# RECALL ACTION BULLETIN

Bull. No: A/B/D233

MODEL/DERIVATIVE	AFFECTED RANGE:
Range Rover V8 Automatic models	XA410482 to 1A452817
Discovery Series II Automatic models	XA220000 to 1A299999 1A700000 to 1A713517
Build date range	June 1998 to December 2000

**AUTOMATIC GEARBOX FLUID CONTAMINATED WITH WATER**

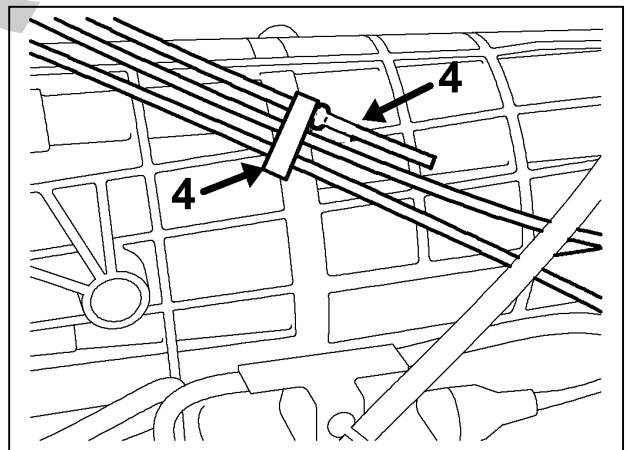
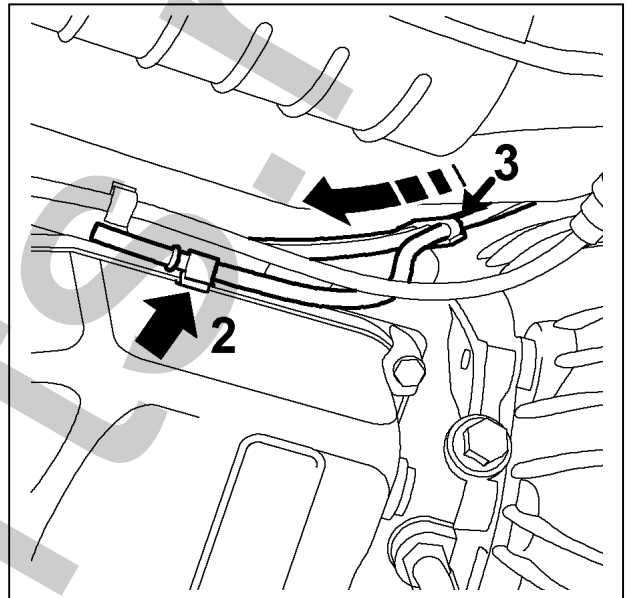
- A small number of vehicles at the start of the Discovery VIN range may have gearbox breather pipes that are routed into the engine bay located at the engine rear lifting eye. This routing is deemed acceptable and no further work is required on these vehicles. Submit a warranty claim for inspection only, utilising Option code F for UK markets and 44.24.89/32 for all overseas markets.
- Likewise, a small number of vehicles that appear at the end of the VIN range may have gearbox breather pipes routed correctly, up and over the top gearbox. No further work is required on these vehicles, submit a warranty claim for inspection only, utilising Option code F for UK markets and 44.24.89/32 for all overseas markets.
